Corner Case Discussion

IEEE802.3az Figure 40-15b

Figure 40–15b—PHY Control state diagram, part b (optional)

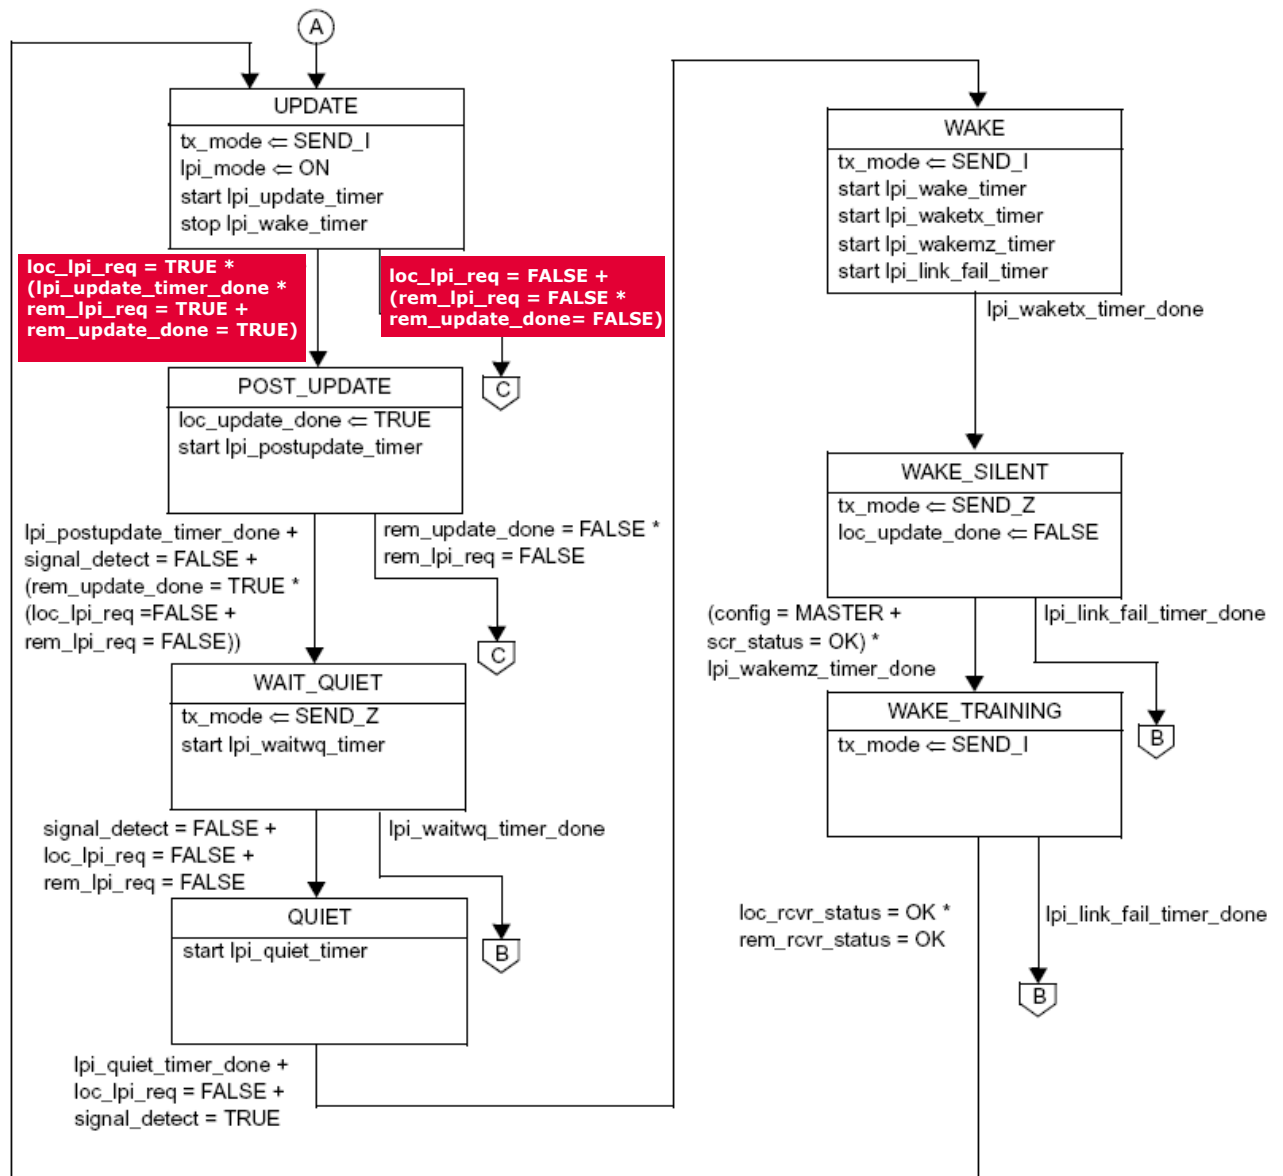
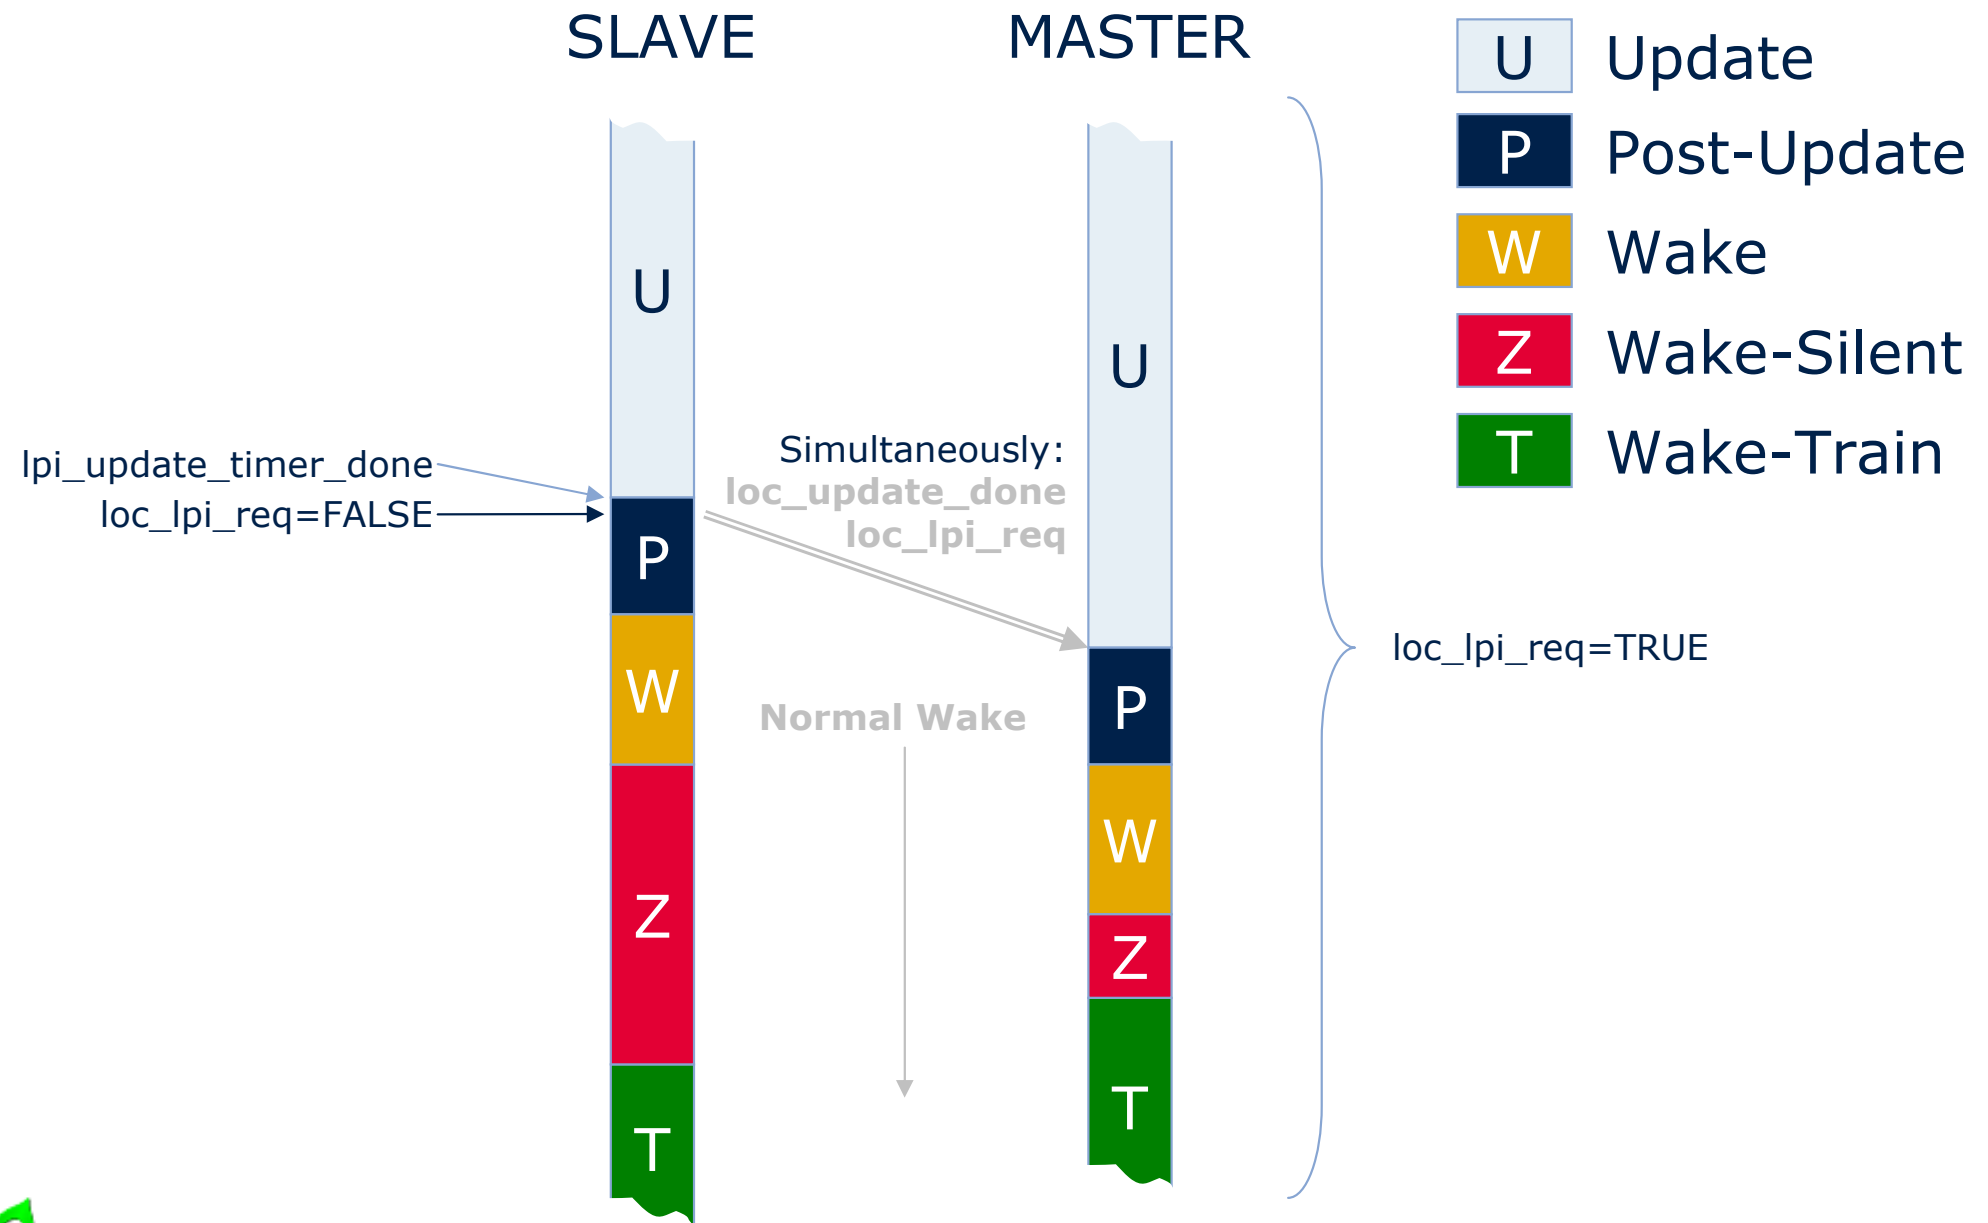
- A corner case in the IEEE802.3az-clause40 PHY control state diagram has been identified (see Figure 40-15b)
- Scenario:
 - Master continuously gets `loc_lpi_req=true`
 - Master and Slave are in UPDATE state
 - Slave gets timed out (`lpi_update_timer_done`) and transitions into POST_UPDATE. At the same time or shortly after (but within the same symbol period) the slave gets a LPI deassert by `loc_lpi_req=false`
 - Slave sends both inband status information simultaneously to the Master (since it can only signal with 8ns time-resolution):
 - `loc_update_done=true`
 - `loc_lpi_req=false`
- Issue:
 - Master is still in UPDATE and must take immediate transition to IDLE as of Figure 40-15b
 - Slave proceeds with a WAKE and times out into WAKE_SILENT thus ceasing transmission of IDLE symbols which will kill the Master's update of filter coefficients.

- The state-diagram in Figure 40-15b assumes asynchronous timing.
- However, inband signaling is used to exchange the variables between link-partners. These signals are thus “synchronized” to the symbol period.
- Consequently, the time-resolution for some of the variables is 8ns and not asynchronous.
- This in turn causes the corner case as described before since it generates the possibility that `LOC_UPDATE_DONE=TRUE` and `LOC_LPI_REQ=FALSE` are sent simultaneously on the line though being generated in a sequence.
- Since the current implementation of state-transitions in UPDATE does assume both signals not asserted at the same time this corner case is generated.

- Change:**
 rem_lpi_req in branch condition from UPDATE to POST_UPDATE is changed to qualify the lpi_update_timer expiration only to allow a link-partner to follow into POST_UPDATE for a WAKE
- Include:**
 loc_update_done into branch condition from UPDATE to IDLE to judge validity of rem_lpi_req
